# Access Compliance Report Public Rights-of-Way (Curb Ramps)

Main Street: SILVER\_FOX\_RD Cross Street: ACECA\_DR Location: NE

ADA ID: RPAT211202145307 Ramp Type: Type 1 - Perpendicular Diagonal Initial Pass/Fail: Fail Overall Compliance: No Severity Score: 2

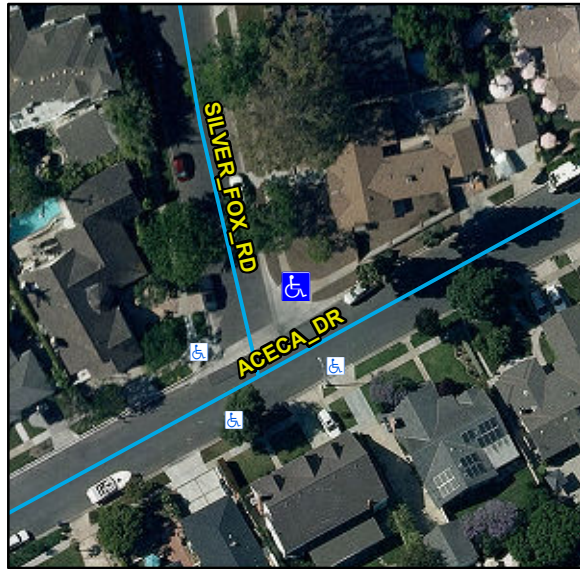
| Compliance | Description                           | Data | Compliance | Description                   | Data |
|------------|---------------------------------------|------|------------|-------------------------------|------|
| No         | Ramp Cross Slope (%)                  | 3.5  | N/A        | Flare Traversable LT          | N/A  |

Remove & Replace Curb Ramp With Two New Directional Ramps or Equivalent.

R204.3, R304.5.3, STD 1115
